LATE REPRESENTATIONS FOR PLANNING PANEL

Application Ref.: 4/21/2136/0B1.

Development: VARIATION OF CONDITION 2 OF PLANNING APPROVAL 4/20/2179/0F1 RELATING TO THE REVISION OF THE LANDSCAPE LAYOUT PLAN, THE SUBSTITUTION OF THE DWELLING TYPE ON PLOT 64 AND A MINOR INCREASE IN THE FLOOR HEIGHT ON PLOTS 43, 45, 47 AND 64.

4/21/2136/OB1 The Mount Phase 4 proposed 8 residential units – Noise from the existing 15kw turbine 120m away at Mount Farm

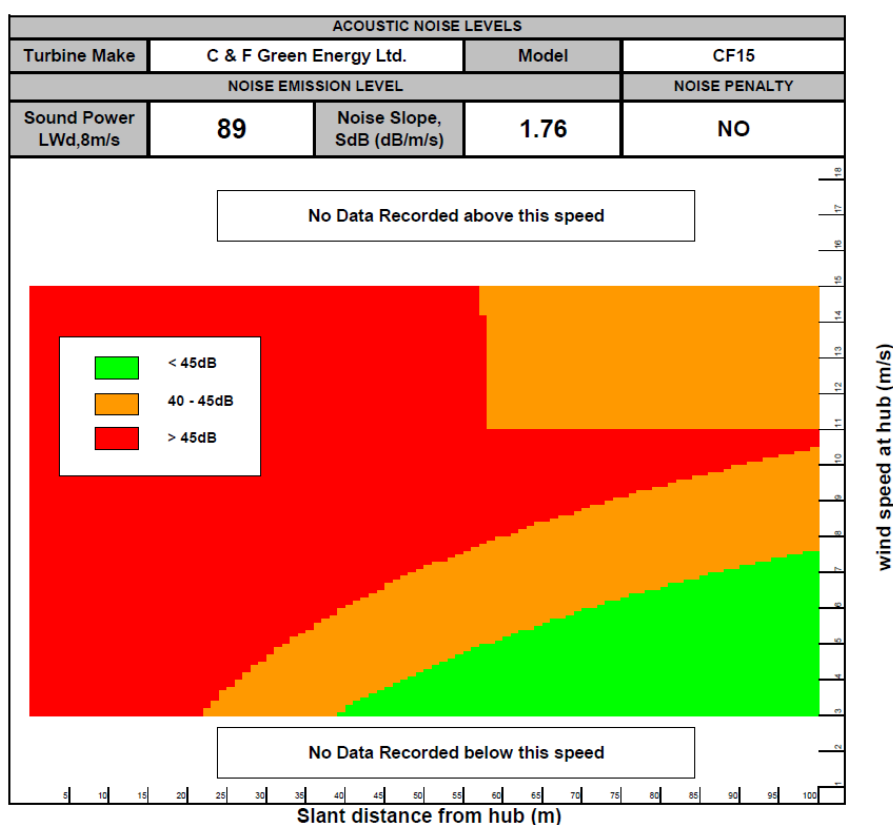
The background monitoring location was located adjacent to the local road network and may not be representative of the location of the proposed dwellings closest to the turbine. Background monitoring was only conducted for a 15-minute period during the night-time. This is too short to present representative background sound levels over a range of wind conditions. The background survey did not consider daytime or evening periods when residents could be using external area. The monitoring does not consider the background sound levels during different wind speeds and directions. No details of wind speed during the background monitoring was provided.

It could have been beneficial to establish the existing turbine noise levels at the location of the closest proposed dwellings, 120m south of the wind turbine. Our view is that to be of any valuer, any survey for this type of assessment would require at least one week of continuous noise monitoring and with a 10m wind mast also recording wind conditions at the same time.

Therefore, the presented background sound levels cannot be relied on.
